ADDENDUM NO. 1

Date of Addendum: 8/5/11

PROJECT NAME: Proposed 48-inch / 42-inch Water Line along Existing Easements, West Orem, Chimney Rock, River Bluff Summit Ridge, Wood River, and Coachcreek from Sims Bayou Pump Station to Hillcroft and SWPS Chlorine Building Improvements

PROJECT NO: WBS No. S-000900-0109-4

WBS NO. S-000900-109-4	
DRAWING SCALE	
CITY OF HOUSTON PM ARTHUR MORRIS, P.E.	
SHEET NO. 41E OF 208

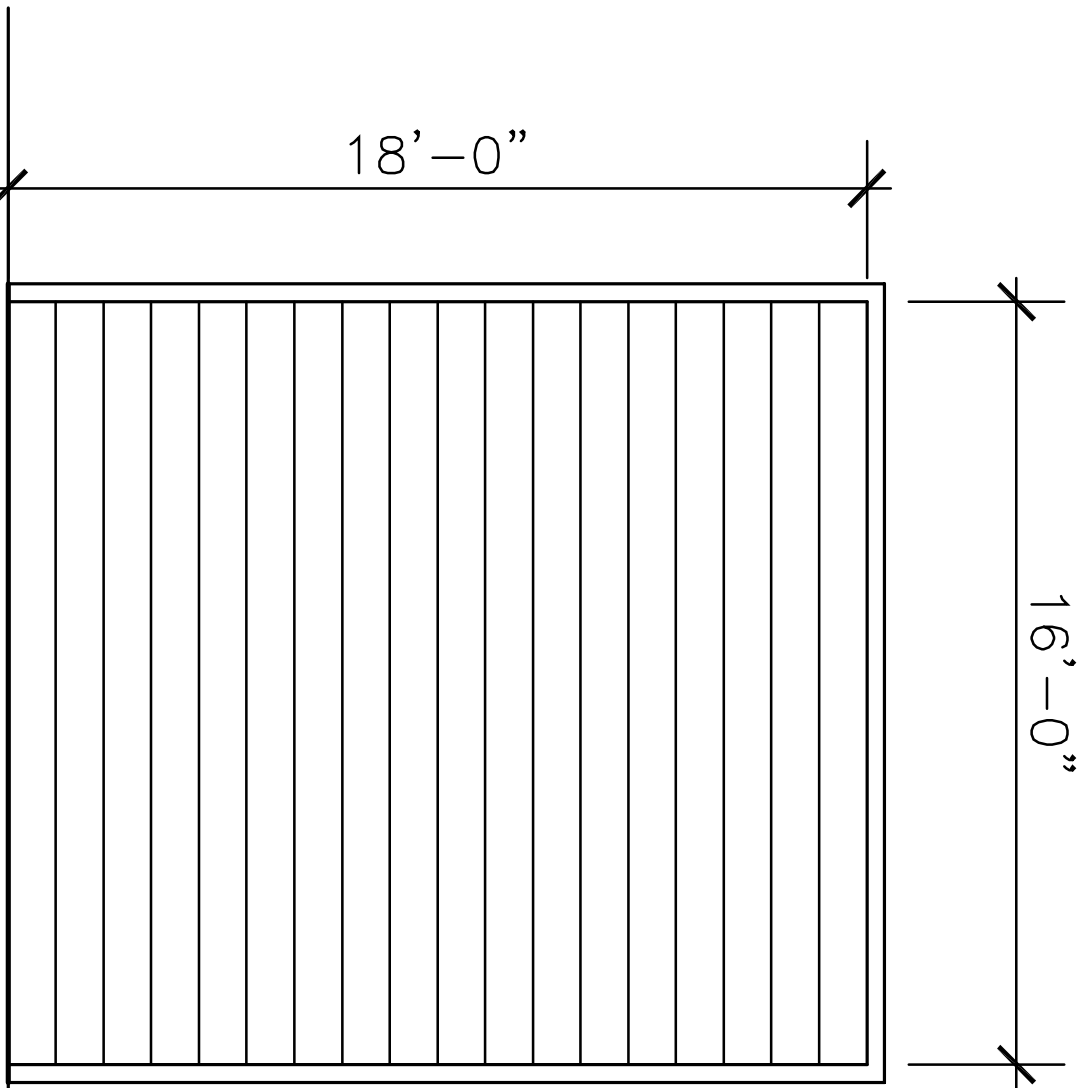
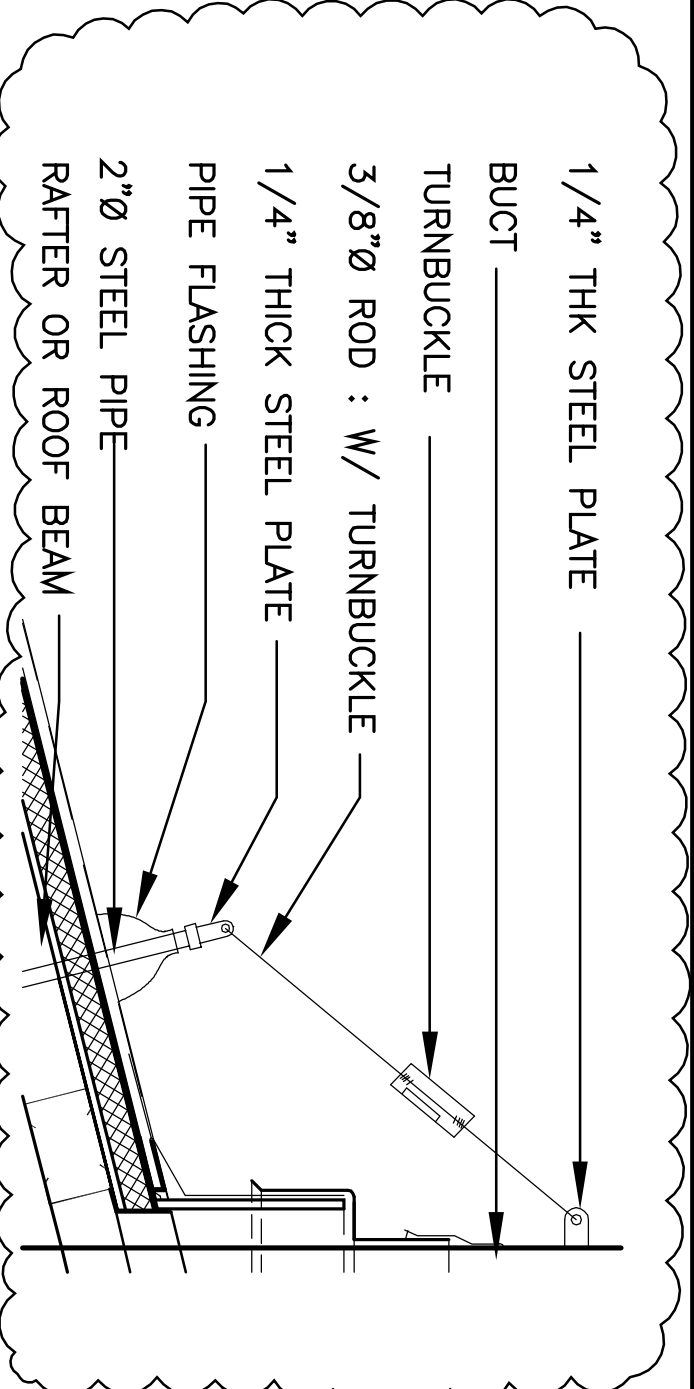
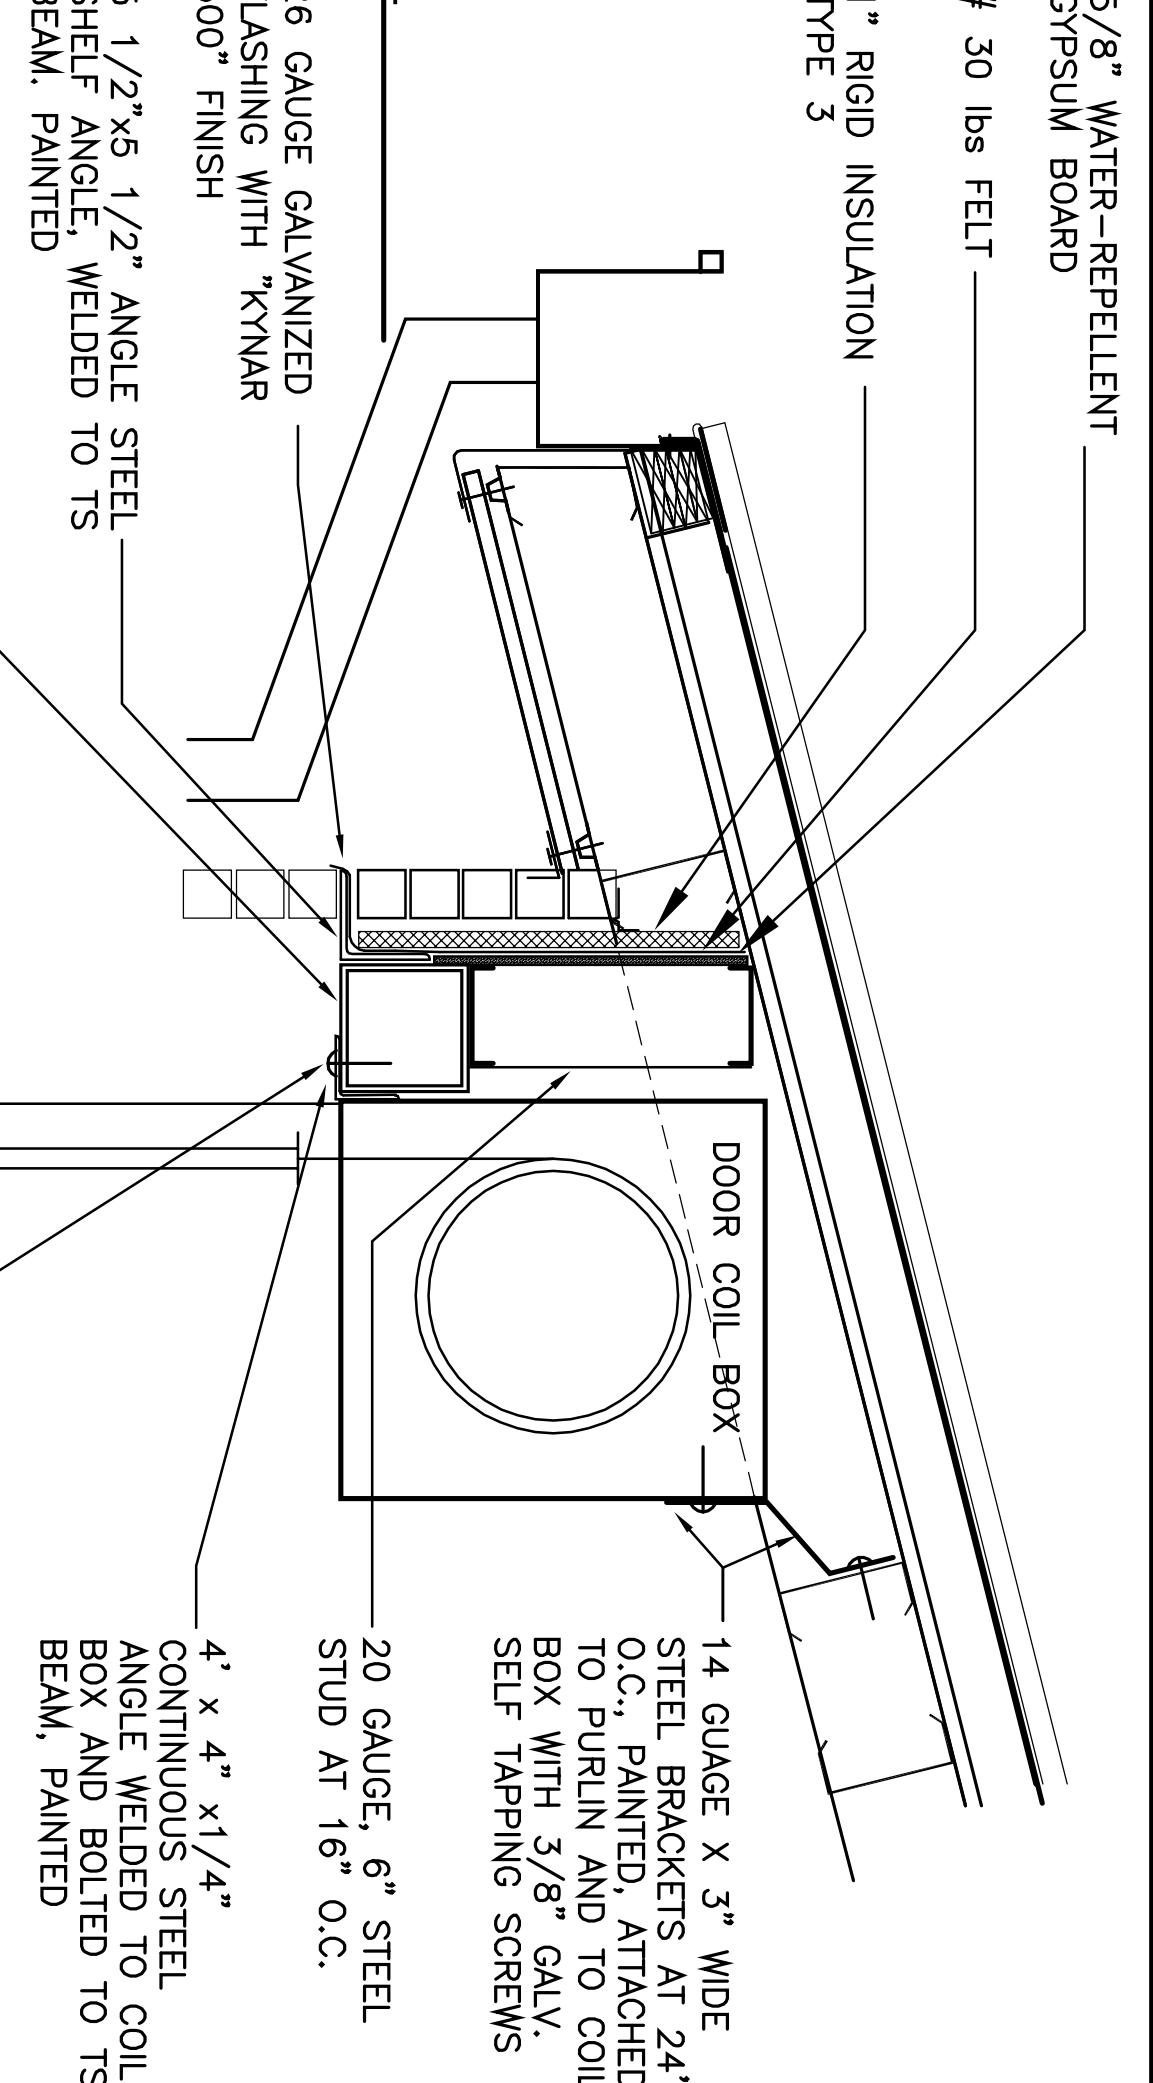
24. Sheet 41 B – Delete the following note: “4. The Building is Not Fire Sprinkled”
25. Sheet 41 D – Replace Entire Sheet.
26. Sheet 41E- Replace Entire Sheet.

APP.	REVISIONS	DATE	No.
	ADD GUY WIRES ON EXHAUST DUCT	8-4-11	1

SECTION
 3/37 SCALE: 1/2"=1'-0"

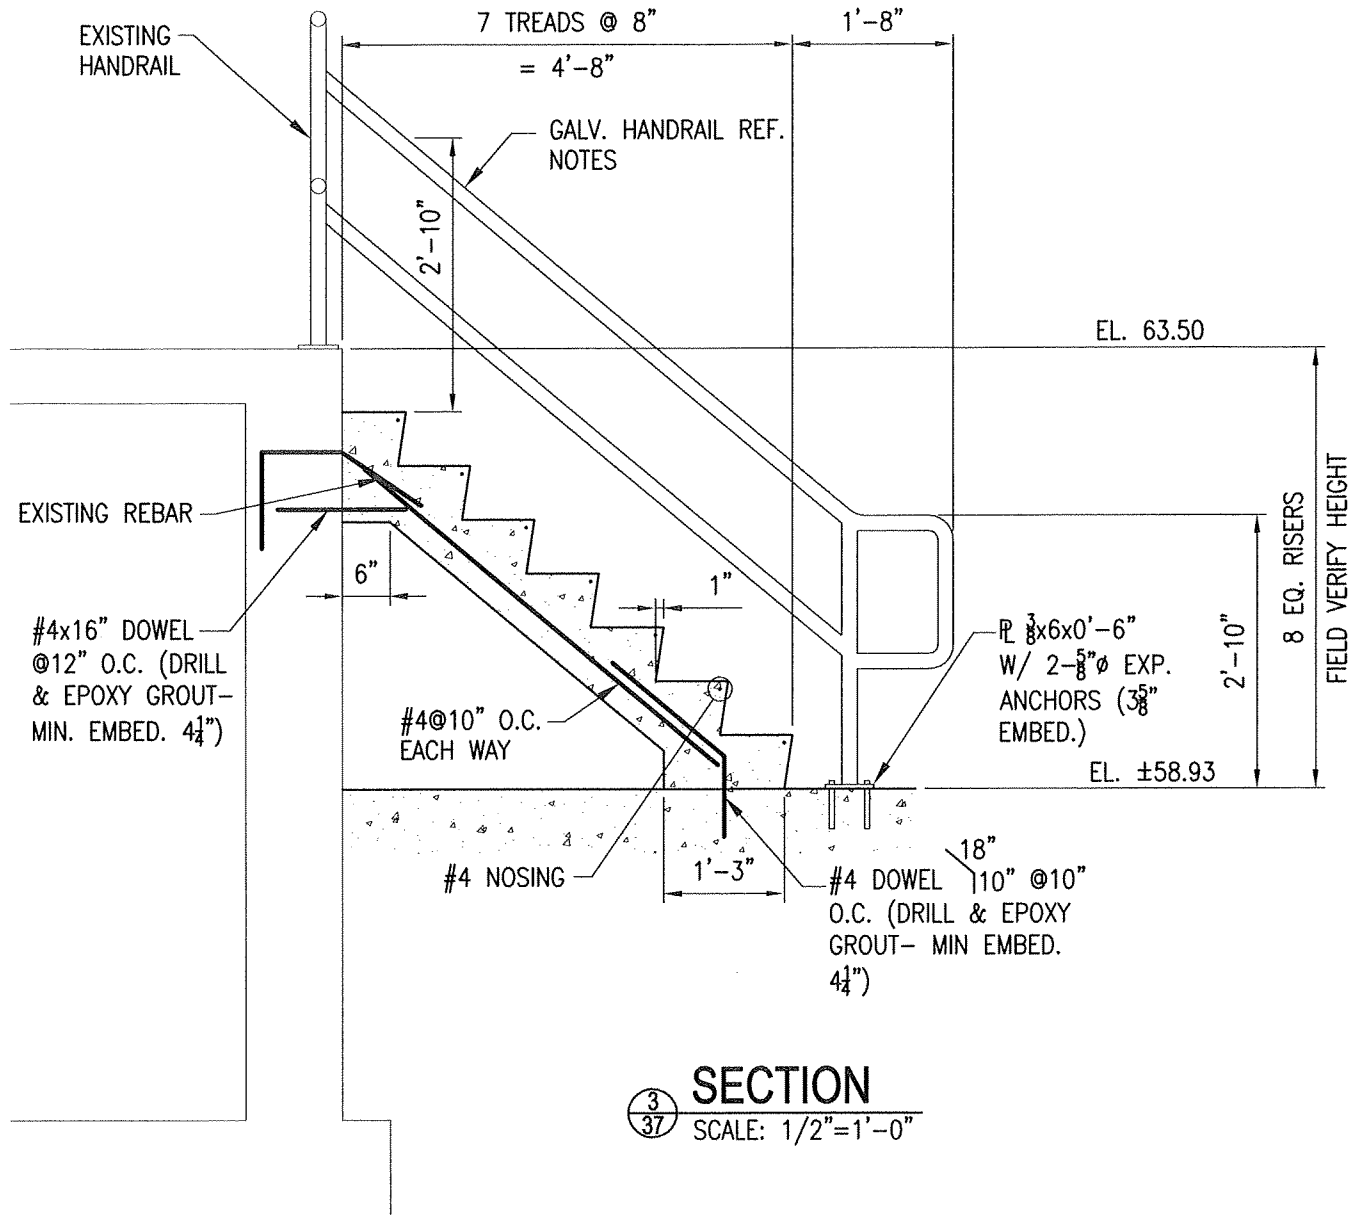
22. Sheet 37 – Delete detail 3 and replace with revised detail 3 shown in Exhibit A.
23. Sheet 37 – Add the following note to detail 4 and 5 “Drill & epoxy grout #5 reinforcing bars using Hilti HVA Capsule Adhesive Anchoring System or approved equal. Embedment shall be a minimum of 5” into existing concrete.”

**EXHIBIT A
 ADDENDUM NO. 1**

6 46 HORIZONTAL GATE VALVE WITH CONCRETE SADDLE
N.T.S.

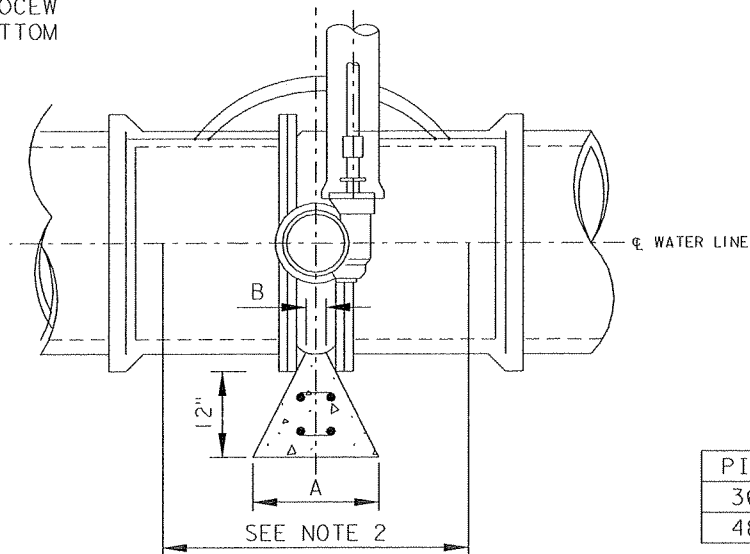
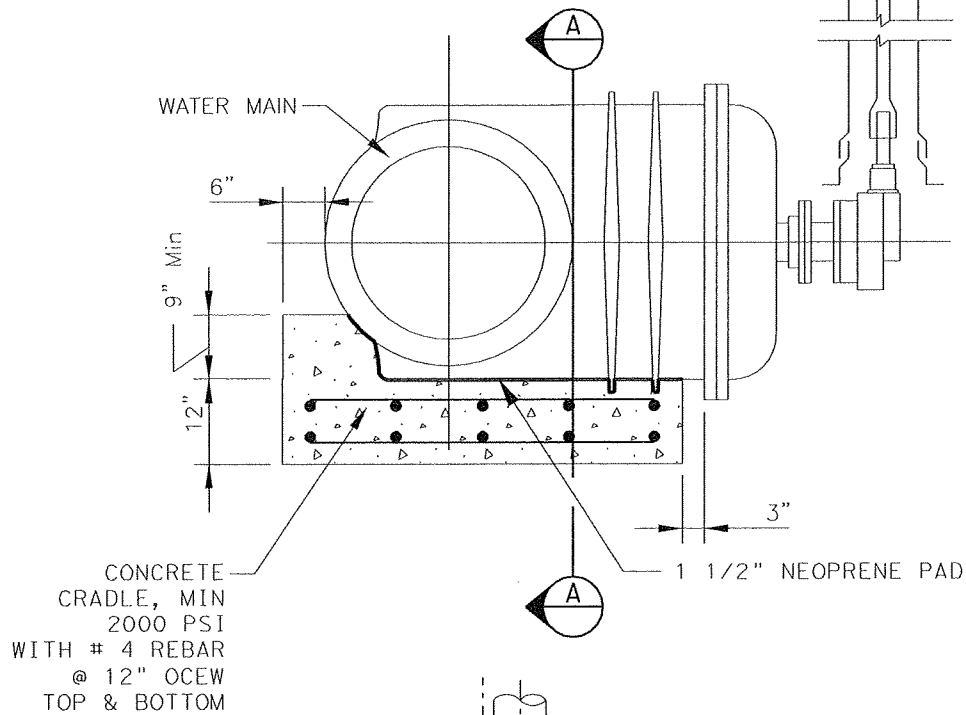
37. Sheet 46 – Add Detail 6 – Horizontal Gate Valve with Concrete Saddle. See Attached Exhibit B for Detail.
38. Sheet 48 – Delete table titled "MINIMUM TUNNEL LINER/CASING SIZES AND THICKNESS" and replace with the following table:

EXHIBIT B
ADDENDUM NO. 1
